Power Relay of G5Q series Modification Notice of Packing method and bottom of Base shape and Product Code Change.(For EU area only)

All series of G5Q (Include G5Q-EL, EL2)
< Refer to the " [Details of applicable model] " . >

Packing

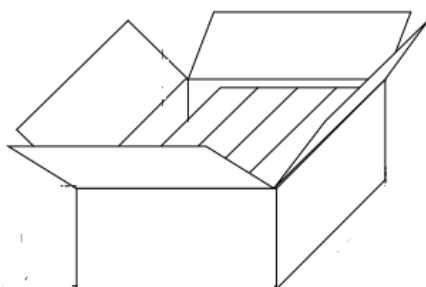
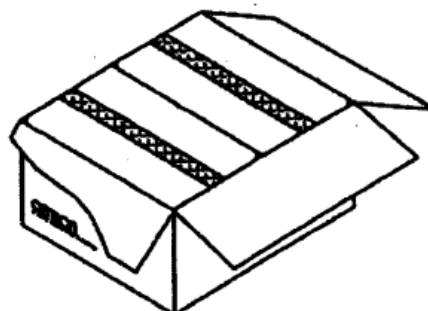
Improvement of Productivity.

Before the change

- Stick (Material:PET)
- 1 Stick : 40 pcs

- Packing Box
- 1 Packing Box : 400 pcs(10 Stick)
- L=461mm W=122mm H=47mm

- CARTON BOX
- 1 CARTON BOX : 2000 pcs(5 Packing Box)
- L=263mm W=540mm H=138mm

After the change

- Tray (Material: Styrene foam)
- 1 Tray : 100 pcs

- Sleeve Packing
- 1 Sleeve Packing: 500 pcs (5 Tray)
- L=260mm W=174mm H=182mm

- CARTON BOX
- 1 CARTON BOX : 1000 pcs (2 Sleeve Packing)
- L=358mm W=265mm H=196mm
